SERVICE NO. 1131A BULLETIN

Date: January 18, 2016

**INSPECTION OF 'CAST' MAIN LANDING GEAR
STRUT CYLINDERS**

SB 1131A adds instructions and illustrations to clarify the inspection procedure

Figure 1
Inspection Area

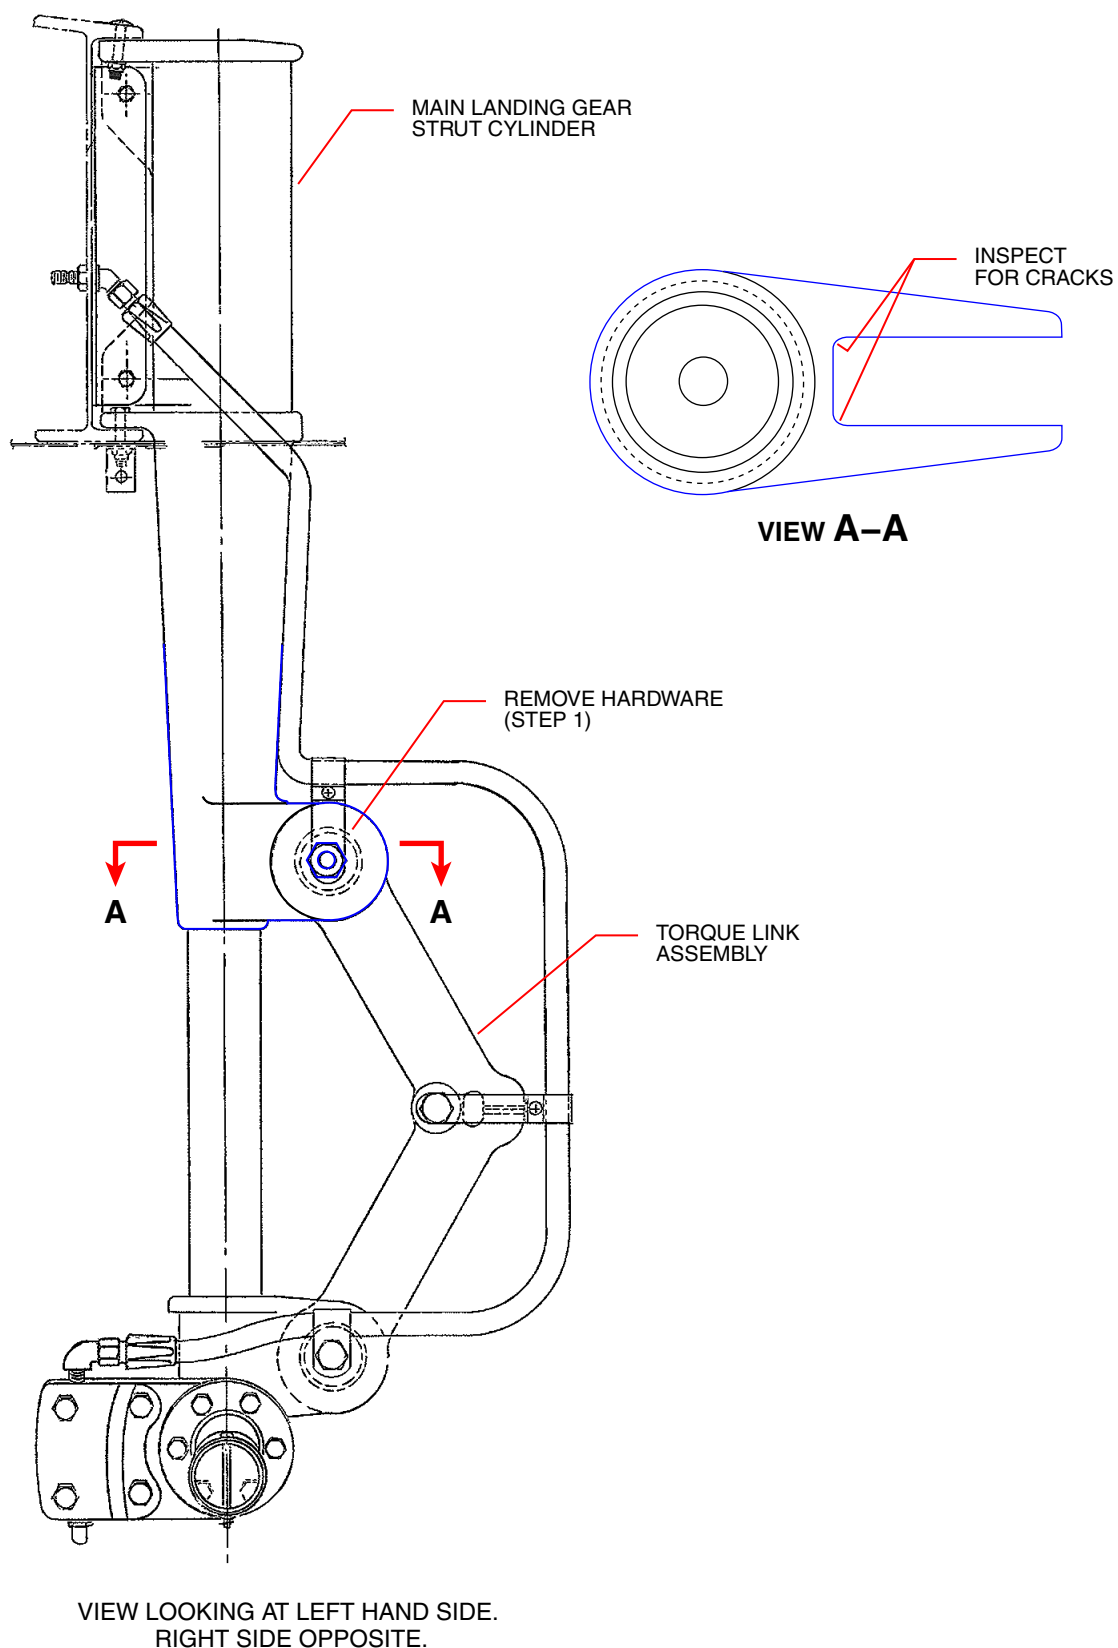
1. Disconnect the torque link assembly by removing the cotter pin, nut, washers and bolt at the location indicated in Figure 1. Discard the cotter pin. Note the arrangement of all hardware, including shims and spacers, for reinstallation. To provide access for this inspection, rotate the torque link assembly away from the torque link attach lugs.

2. Thoroughly clean the area to be inspected as indicated in Figures 1 and 2, using a suitable cleaner.
3. Using a 10X power magnifying glass, visually inspect the radii of the main landing gear strut cylinder's torque link attach lugs for cracks. Refer to Figures 1 and 2 for the inspection locations. If no cracks are found by visual inspection, proceed to liquid penetrant inspection per Chapter 5, Section 5, of FAA Advisory Circular AC 43.13-1B, to check for cracks. Strip the paint and primer from the areas to be inspected using a commercially available chemical paint stripper, taking care to only remove paint and primer from the inspection areas.

4. If a crack is detected, prior to further flight replace the “cast” main gear strut cylinder with the “forged” main gear strut cylinder per the applicable Piper Airplane Maintenance Manual (see Material Required, below, for the appropriate part number to order).

5. If no cracks are detected, then thoroughly clean the affected surfaces and touch up the primer and paint where it was removed.
6. Reconnect the torque link assembly to the main landing gear strut cylinder:
 - Reinstall all components that were removed in Step 1, being careful to return all components to their original location.
 - Install a new cotter pin, part number specified in the appropriate Piper Airplane Parts Catalog.
7. Make a logbook entry documenting compliance with this service bulletin.
